Technische Information

13/2018

911 GT3 Cup (991) Gen.II

MESH INTAKE AIR SIDE RADIATOR

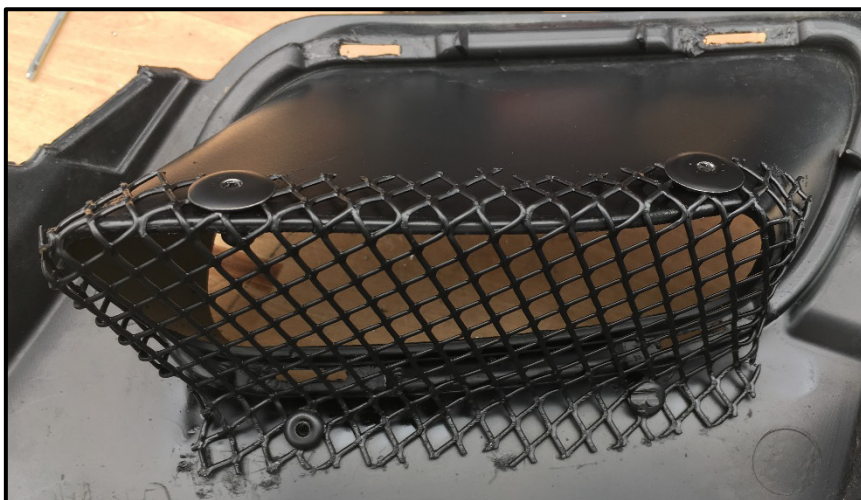
Porsche Motorsport weist darauf hin, dass es bis zur Verfügbarkeit einer original Porsche Abdeckung erlaubt ist, die kleinen Kühlluftöffnungen (rot markiert im Bild) der Seitenkühler durch ein modifiziertes Originalgitter abzudecken.

Das Gitter muss ursprünglich aus den Gittern der Seitenkühler oder Mittelkühler bestehen.

Porsche Motorsport informs, that it is allowed to cover the small cooling ducts of the side radiators (red frame in the picture below) with a modified original radiator mesh. This solution is legal until original PAG spare parts are available.

The modified mesh has to be fabricated out of original mesh's of the side or mid radiator.

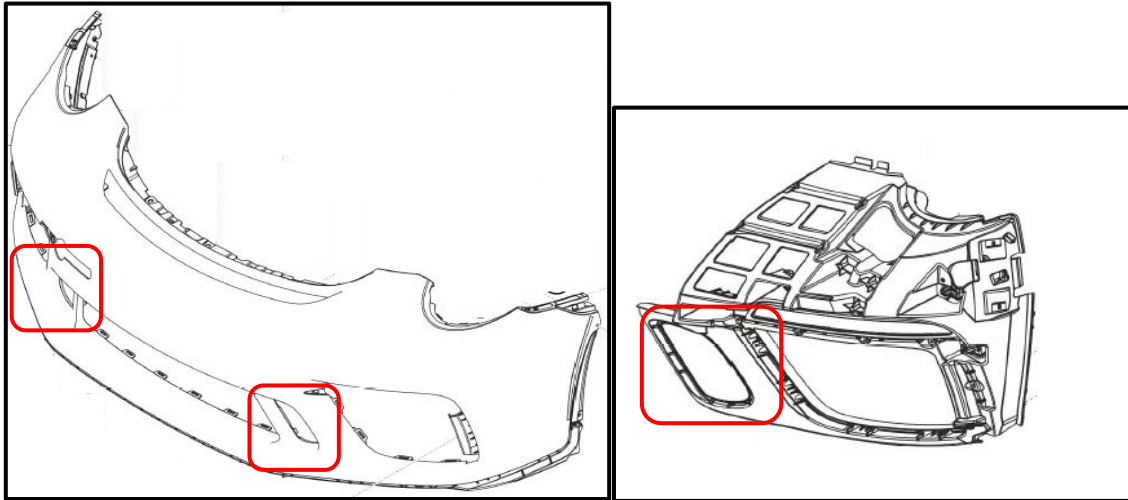
Das Gitter ist mit Nieten fest mit den Halterahmen der Bugverkleidung zu verbinden und wie unten im Bild dargestellt anzubringen.

The mesh has to be fastened by rivets to the retaining frames of the front cover as shown in the picture below.
